BAMX Comments on the CAISO 2018-19 Transmission Plan Stakeholder Presentation Materials from November 16, 2018

The Bay Area Municipal Transmission group (BAMx)¹ appreciates the opportunity to comment on the development of the CAISO 2018-19 Transmission Plan (TP) as discussed during the November 16th stakeholder meeting. We request that the CAISO address the following issues in its draft comprehensive Transmission Plan expected in January 2019.

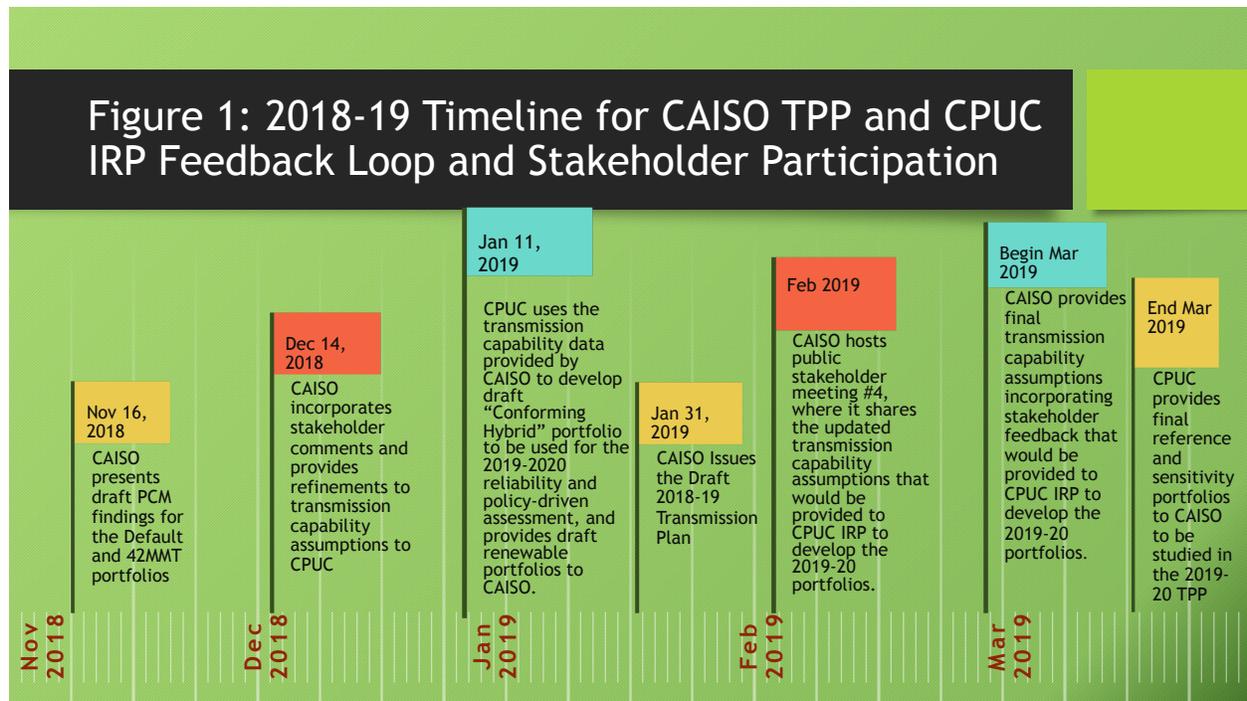
In Figure 1 below, we suggest a timeline for CAISO's consideration entailing an exchange of data and information among CAISO TPP, CPUC IRP, and involved stakeholders. In particular, we request the CAISO to provide its draft transmission capability estimates to the CPUC's IRP comprising the stakeholder feedback in mid-December 2018. This would allow the CPUC adequate time to include those estimates in the RESOLVE model and provide the resulting draft "Conforming Hybrid" resource portfolio - to be used in the 2019-2020 reliability and policy-driven assessment - to the CAISO by mid-January 2019.

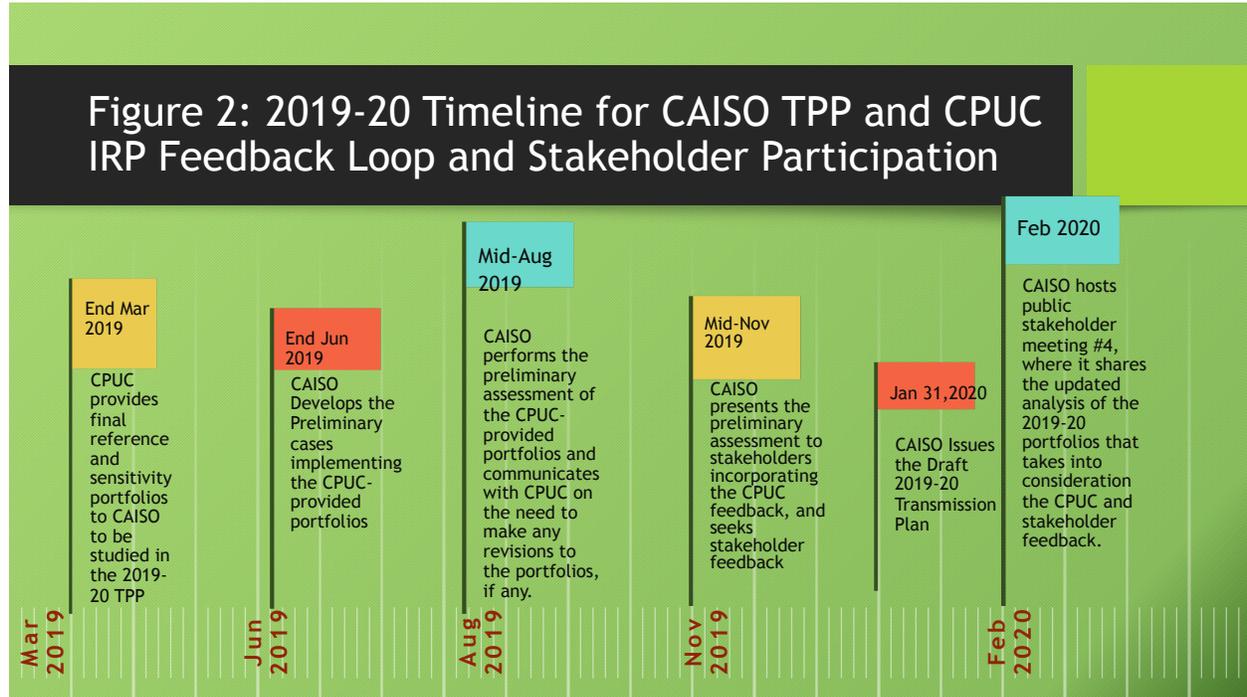
The above BAMx-proposed timeline will ensure that the 2019-20 TPP portfolios used to determine the reliability and policy-driven projects are vetted by stakeholders and would minimize the likelihood any inefficient and unneeded Area Delivery Network Upgrades (ADNU)⁵ being approved under the 2019-2020 TPP. If for some reason, the CAISO and CPUC cannot implement the feedback loops outlined in Figure 1, we suggest the timeline shown in Figure 2 during the 2019-20 TPP.
